CITY OF SAN ANTONIO
**OFFICE OF HISTORIC
PRESERVATION**

BOA-21-10300158
615 E Evergreen – Tobin Hill Historic District
November 15, 2021

Request:

615 E. EVERGREEN ST.
NEW DRIVEWAY
AFTER FRONT PORCH
MODIFICATION

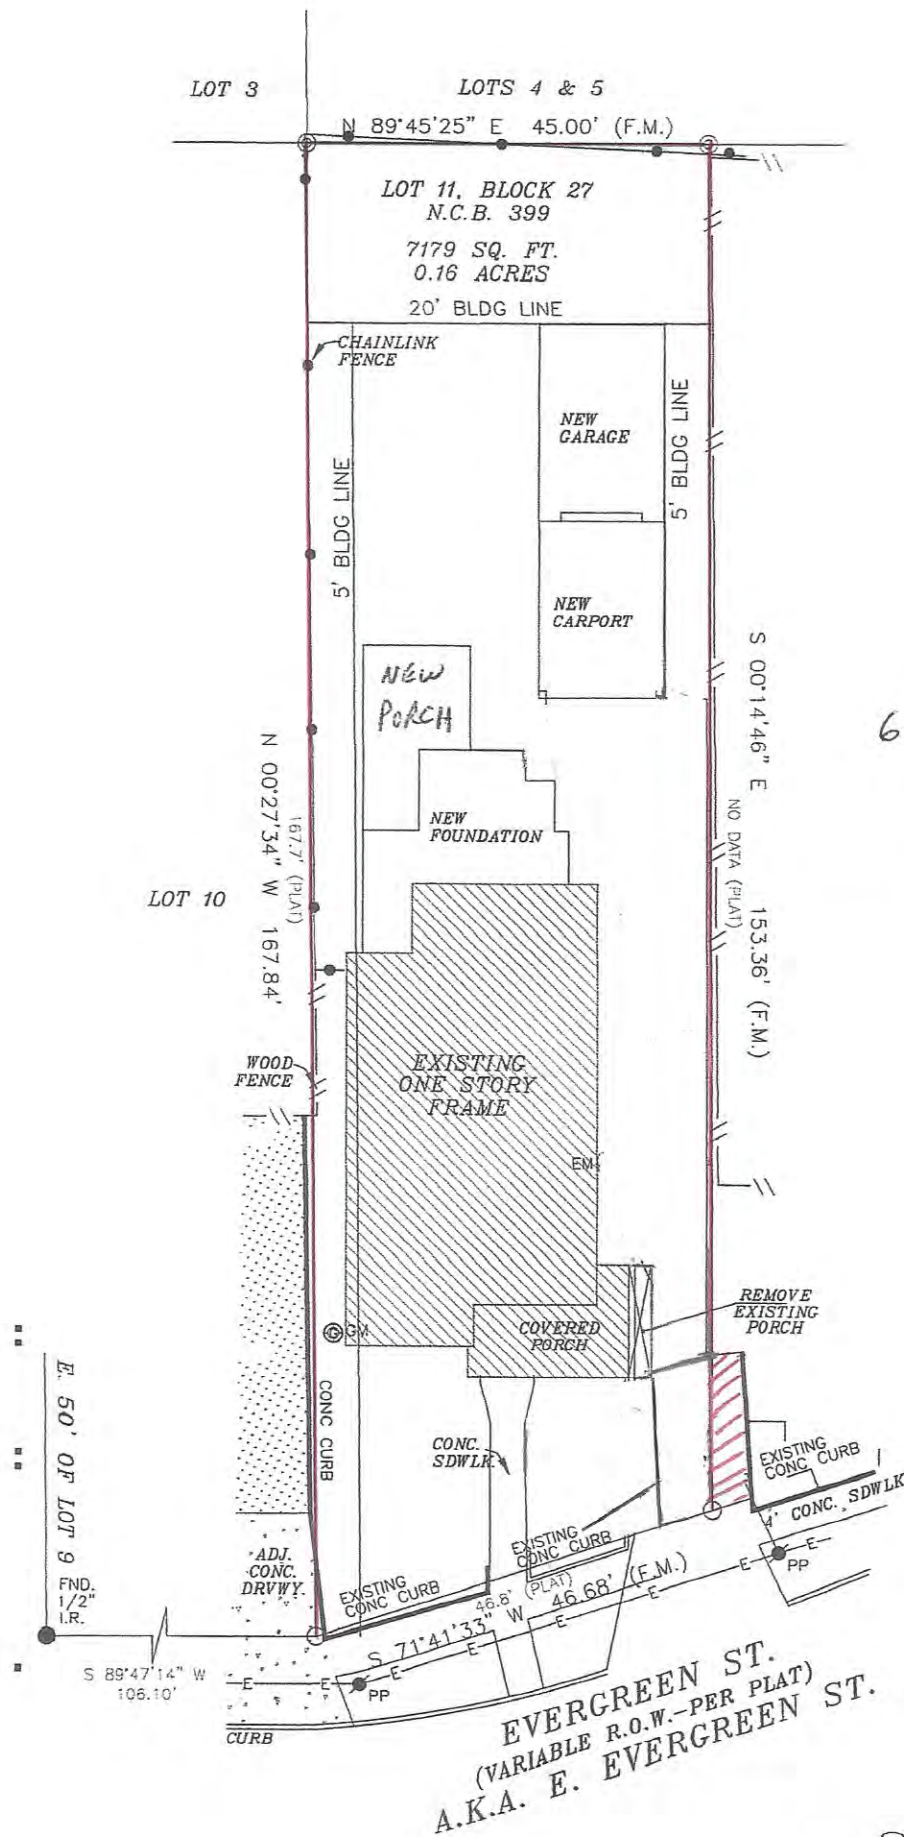
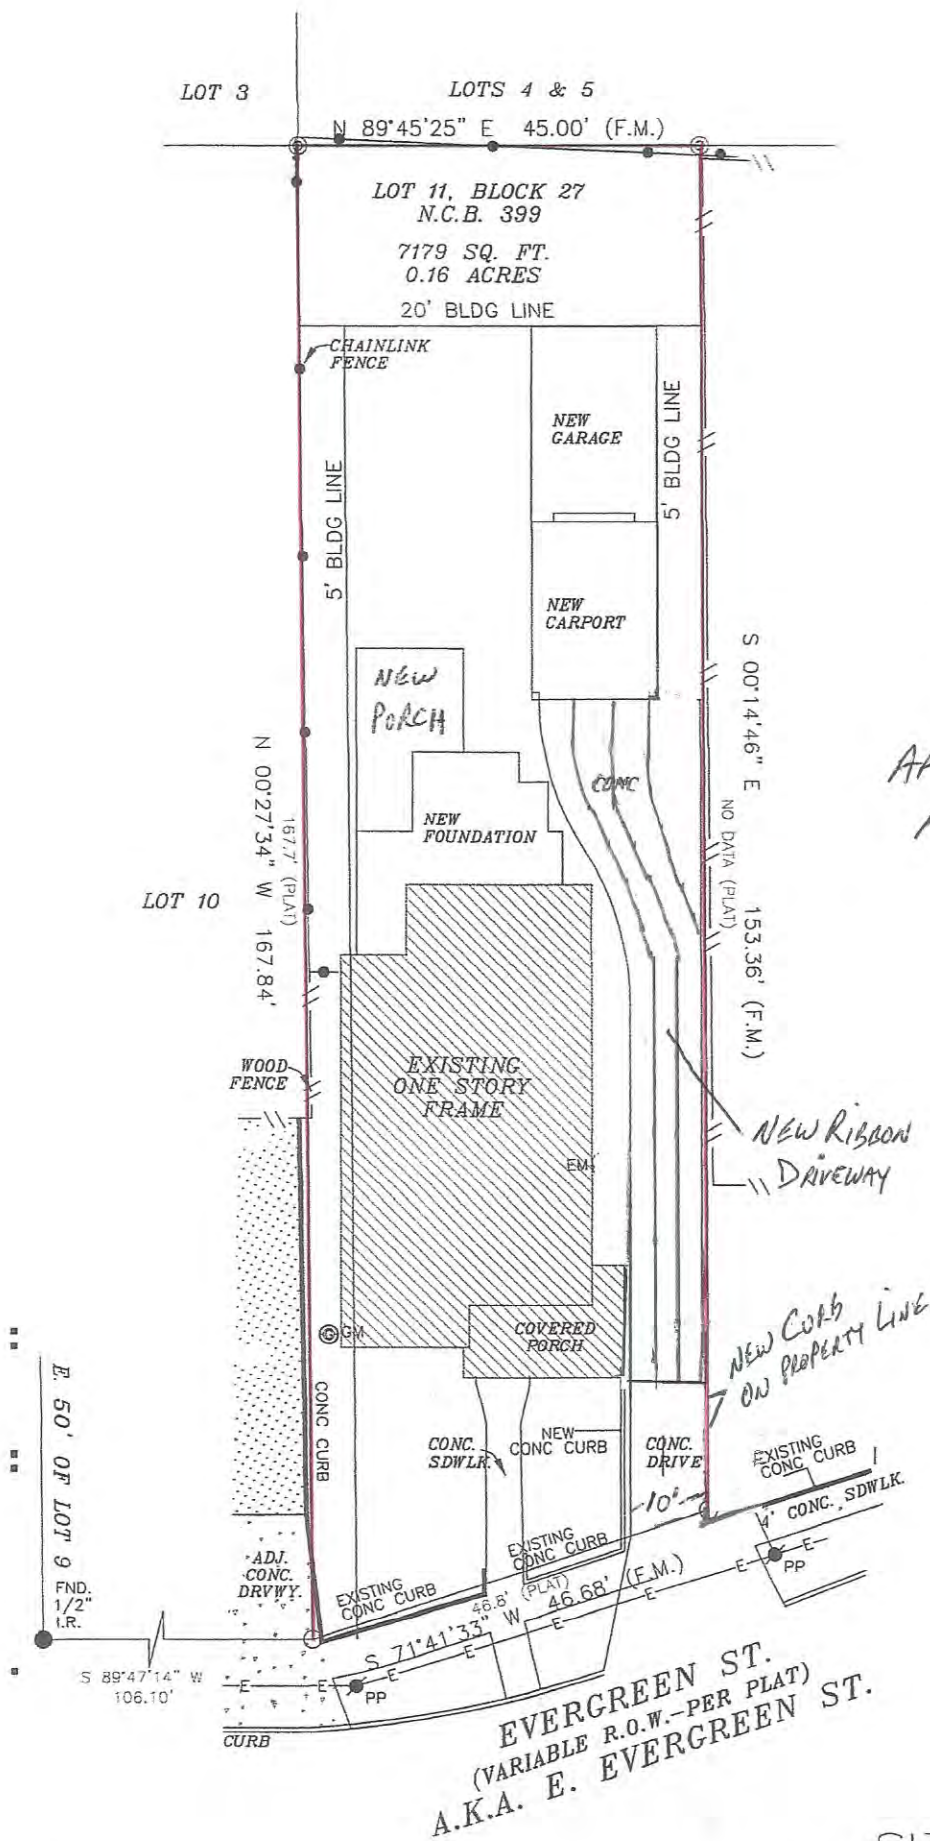
- o. **FRONT PORCH MODIFICATIONS** – The applicant has proposed to modify the existing front porch by reducing the width to the east by 2'-6". The reduction of the front porch width will accommodate the width of the driveway. Guideline 7.A.i for Exterior Maintenance and Alterations states that porches should be preserved. Staff finds the proposal inconsistent with the Guidelines.

- cc. DRIVEWAY AND RETAINING WALL MODIFICATION – The applicant has proposed to modify the existing footprint of the driveway apron, retaining wall, and ribbon driveway so that they are located within the property line. Guideline 5.B.i for Site Elements states that historic driveway configurations, such as ribbon drives, should be retained and repaired in place. Incorporate a similar driveway configuration—materials, width, and design—to that historically found on the site. Historic driveways are typically no wider than 10 feet. Pervious paving surfaces may be considered where replacement is necessary to increase stormwater infiltration. The applicant has proposed to install a 10-foot-wide fully concrete driveway apron and a 9-foot-wide ribbon driveway extending to the rear of the property. As the driveway apron, driveway, and retaining wall modifications require the removal of a portion of the front porch, staff finds the request inappropriate.

Item 3, staff does not recommend approval of the front porch modification based on finding n.

Item 9, staff does not recommend approval of the driveway and retaining wall modifications based on finding bb. In-kind repairs are eligible for administrative approval.
